Condominium Plat (Conversion)
East Hailey Meadows
Conversion of an existing Multi-family structure to
Condominiums

STAFF REPORT

TO: Hailey Planning and Zoning Commission
FROM: Micah Austin, Community Development Director
RE: Preliminary Plat – East Hailey Meadows Condominiums (Conversion)
HEARING: November 10, 2014

Applicant: Tony Ehrenberg and Thomas A. Ehrenberg Living Trust, represented by Bruce Smith of Alpine Enterprises
Project: East Hailey Meadows Condominium Conversion
Request: Preliminary Plat approval with recommendation to the City Council
Location: Lot 6, East Hailey Meadows
Zoning: Limited Residential (LR) within the Townsite Overlay (TO)

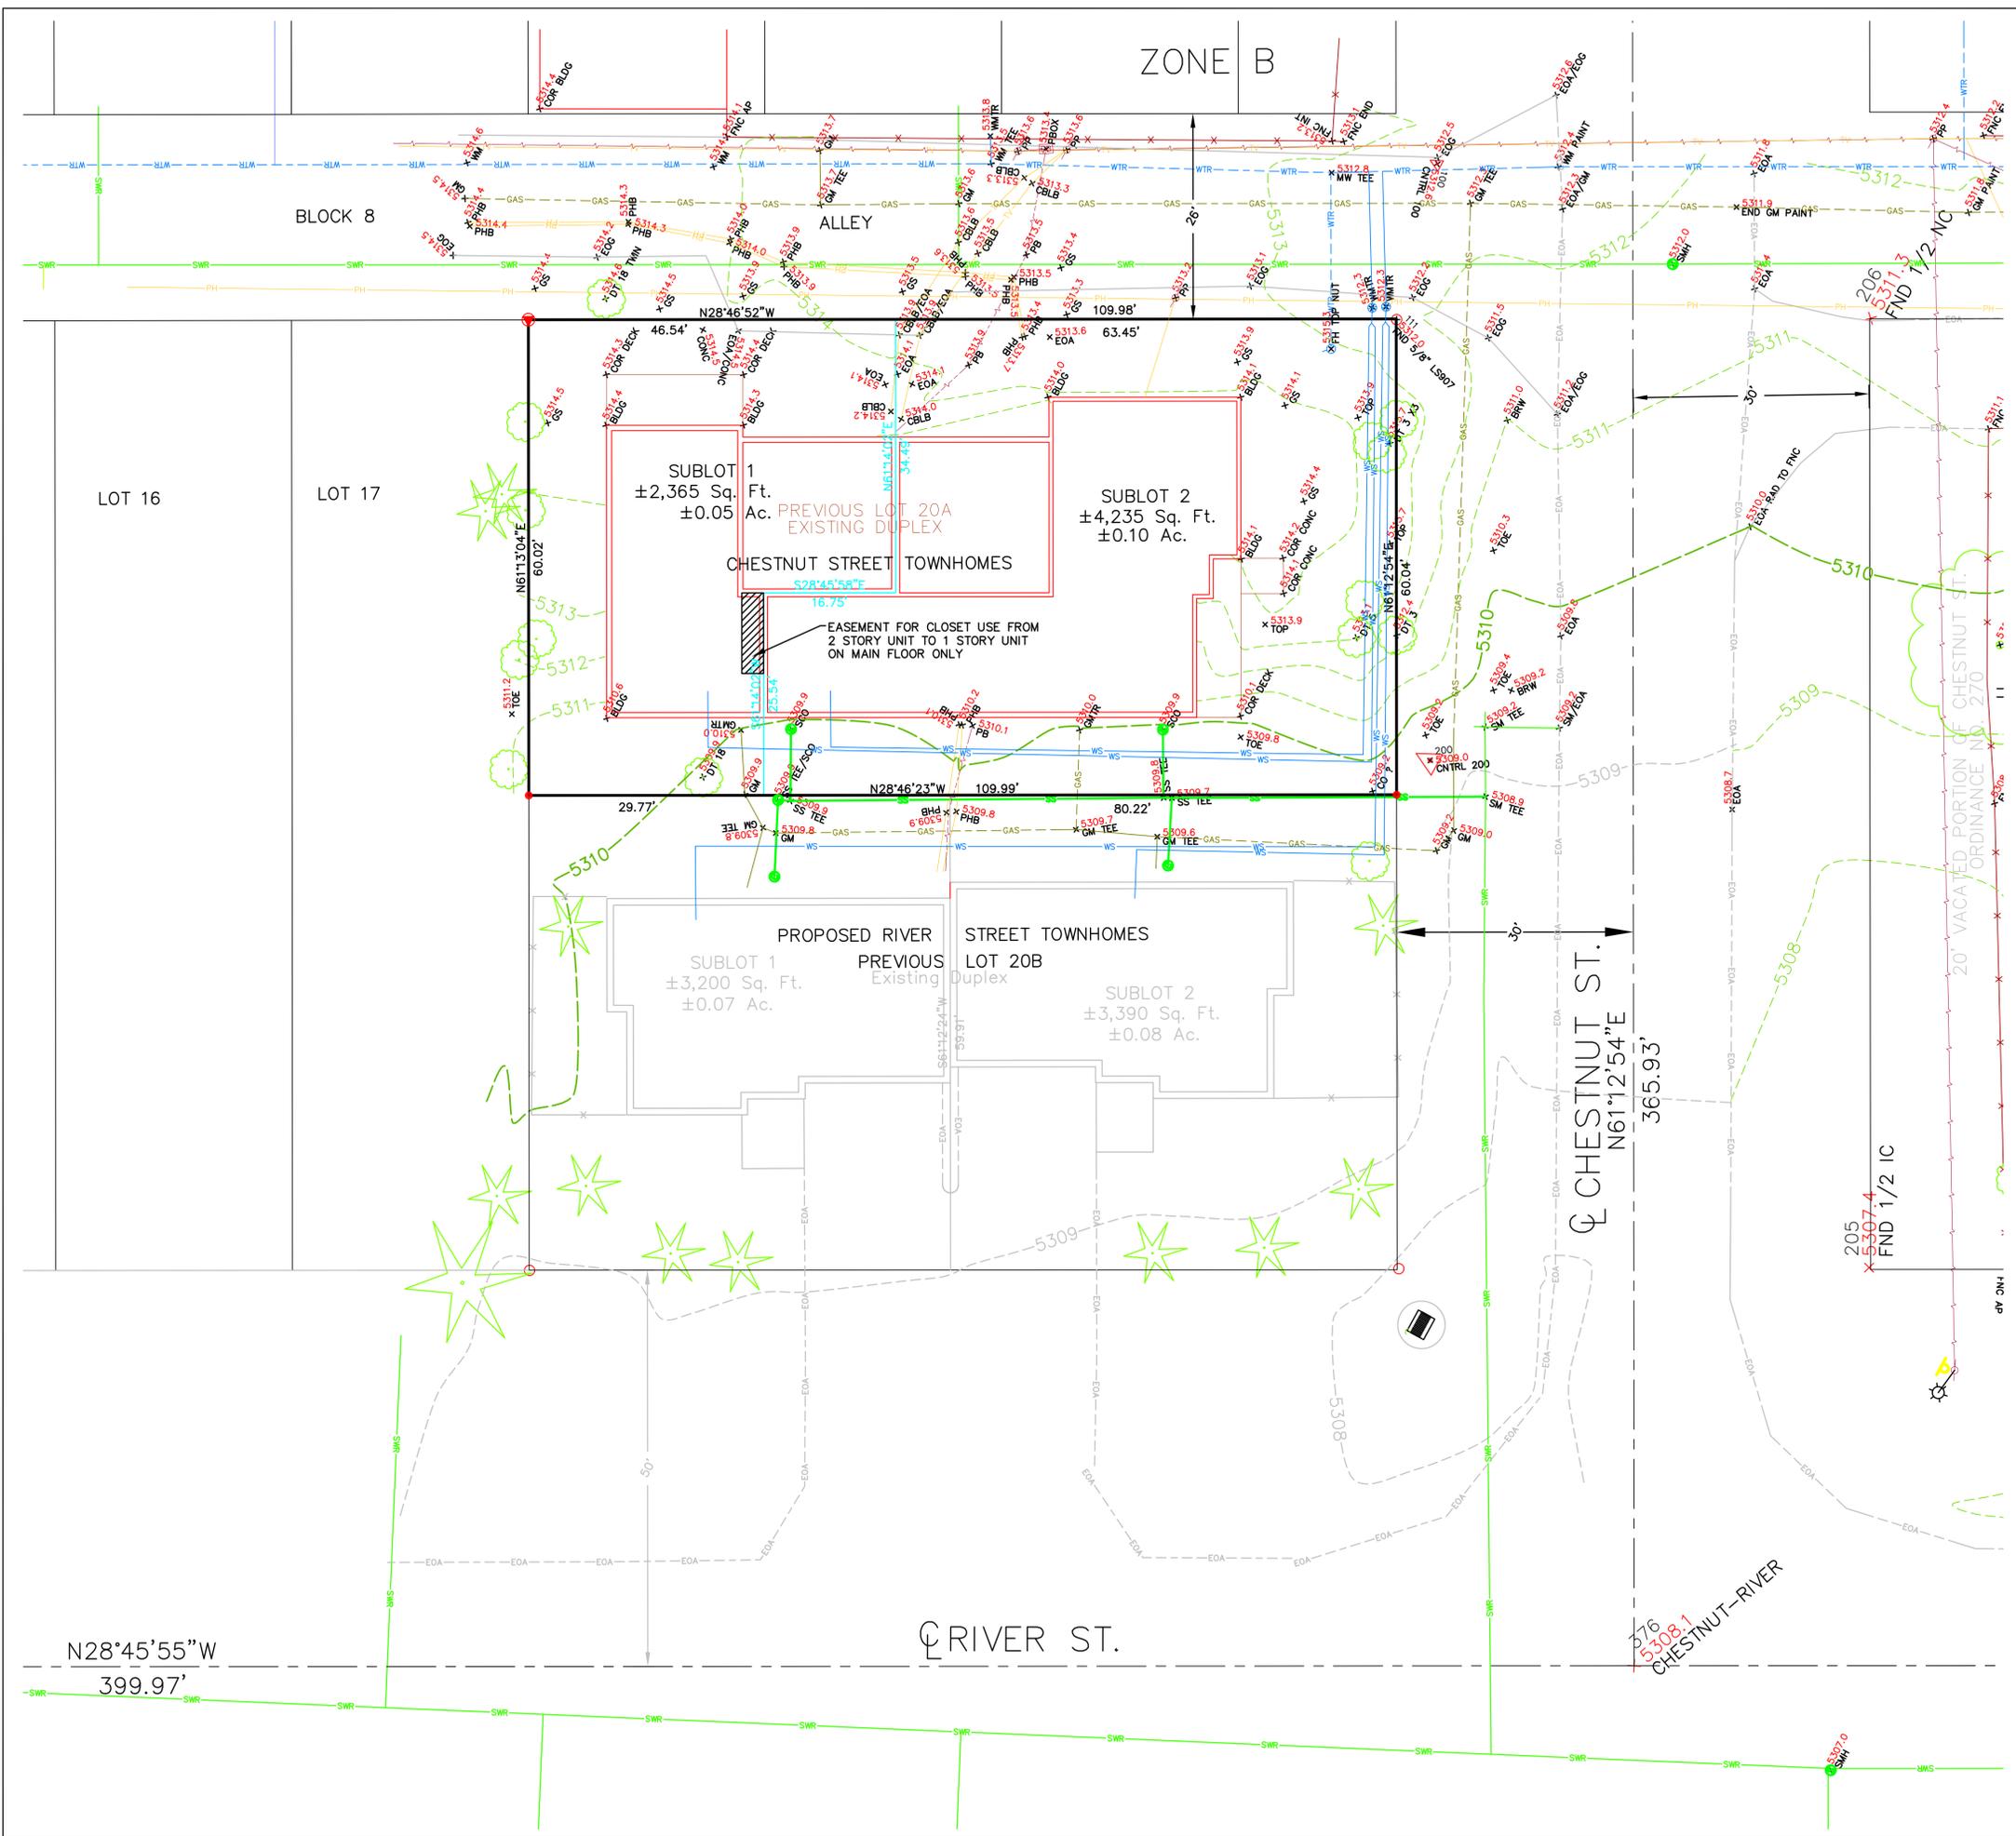
Staff Comments	- The existing alley and Chestnut Street provide access to the two dwelling units and are maintained by the City of Hailey. This is considered a non-conforming use; however the proposed preliminary plat complies with the provisions of Article 13 of the Zoning Ordinance.
<input checked="" type="checkbox"/>	<input type="checkbox"/>	<input type="checkbox"/>	4.1.10.2	Private streets, wherever possible, shall provide interconnection with other public streets and private streets.
			Staff Comments	- The existing alley and Chestnut Street provide access to the two dwelling units and are maintained by the City of Hailey.
<input checked="" type="checkbox"/>	<input type="checkbox"/>	<input type="checkbox"/>	4.1.10.3	The area designated for private streets shall be platted as a separate parcel according to subsection 4.5.3 below. The plat shall clearly indicate that the parcel is unbuildable except for public vehicular and public pedestrian access and ingress/egress, utilities or as otherwise specified on the plat.

<i>Staff Comments</i>	- A current driveway easement provides access to the units and is shown on the current preliminary plat - An easement has been created to accommodate use of a closet. The plat currently reads: "Easement for closet use from 2 story unit to 1 story unit on main floor only." The City's contract Building Official and Plans Reviewer has approved of this easement.
<input checked="" type="checkbox"/>	<input type="checkbox"/>	<input type="checkbox"/>	4.3.8.1	To provide access through or to any property for the purpose of providing utilities, emergency services, public access, private access, recreation, deliveries or such other purpose. Any subdivision that borders on the Big Wood River shall dedicate a 20-foot wide fisherman's access easement, measured from the Mean High Water Mark, which shall provide for non-motorized public access. Additionally, in appropriate areas, an easement providing non-motorized public access through the subdivision to the river shall be required as a sportsman's access.

<i>Staff Comments</i>	- Not applicable
<input checked="" type="checkbox"/>	<input type="checkbox"/>	<input type="checkbox"/>	4.3.8.3	To provide for the storage of snow, drainage areas or the conduct of irrigation waters. Snow storage areas shall be not less than twenty-five percent (25%) of parking, sidewalk and other circulation areas. No dimension of any snow storage area may be less than 10 feet. All snow storage areas shall be accessible and shall not be located over any above ground utilities, such as transformers.
			<i>Staff</i>	- Snow storage easements are shown on the preliminary plat and are

<i>Staff Comments</i>	<i>- Garages and driveways are shown on the plat. All garages are located on the same sub-lot as the principle dwelling and no party walls are proposed. All garages are attached to the principle dwelling.</i>
<input checked="" type="checkbox"/>	<input type="checkbox"/>	<input type="checkbox"/>	8.3	Storage/Parking Areas. Residential townhouse developments shall provide parking spaces according to the requirements of Article IX of the Zoning Ordinance .
			<i>Staff Comments</i>	<i>- Each townhouse is providing two parking spaces with two spaces in the garage and two spaces in each driveway. All required parking is located on-site and does not encroach on the alley or Chestnut Street. - Required number of spaces for this use is 1.5 spaces per unit, resulting in 3 total spaces for the development. Four spaces have been provided.</i>
<input checked="" type="checkbox"/>	<input type="checkbox"/>	<input type="checkbox"/>	8.4	Construction standards. All townhouse development construction shall be in accordance with the IBC, IRC and IFC. Each townhouse unit must have separate water, sewer and utility services, which do not pass through another building or unit.

<i>Comments</i>	<i>adopted at the time of building permit issuance. - The easement for the closet has been approved by the city of Hailey contract Building Official and Plan Reviewer, the Idaho Department of Building Safety.</i>
<input checked="" type="checkbox"/>	<input type="checkbox"/>	<input type="checkbox"/>	8.5	General Applicability. All other provisions of this Ordinance and all applicable ordinances, rules and regulations of the City and all other governmental entities having jurisdiction shall be complied with by townhouse developments.
			<i>Staff Comments</i>	<i>- All provisions of this Ordinance and all other applicable standards shall be complied with by the townhouse development.</i>
<input checked="" type="checkbox"/>	<input type="checkbox"/>	<input type="checkbox"/>	8.6	Expiration. Townhouse developments which have received final plat approval shall have a period of three calendar years from the date of final plat approval by the Council to obtain a building permit. Developments which have not received a building permit, shall be null and void and the plats associated therewith shall be vacated by the Council. If a development is to be phased, construction of the second and succeeding phases shall be contingent upon completion of the preceding phase unless the requirement is waived by the Council. Further, if construction on any townhouse development or phase of any development ceases or is not diligently pursued for a period of three years without the prior consent of the Council, that portion of the plat pertinent to the undeveloped portion of the development shall be vacated.

- b) All City infrastructure requirements shall be met as outlined in the Hailey Subdivision Ordinance and further detailed in the Findings of Fact as approved. Detailed plans for all infrastructure to be installed or improved at or adjacent to the site shall be submitted for Department approval and shall meet City Standards where required. Infrastructure to be completed at the applicant’s sole expense and shall include all infrastructure improvements as identified in the Findings of Fact.
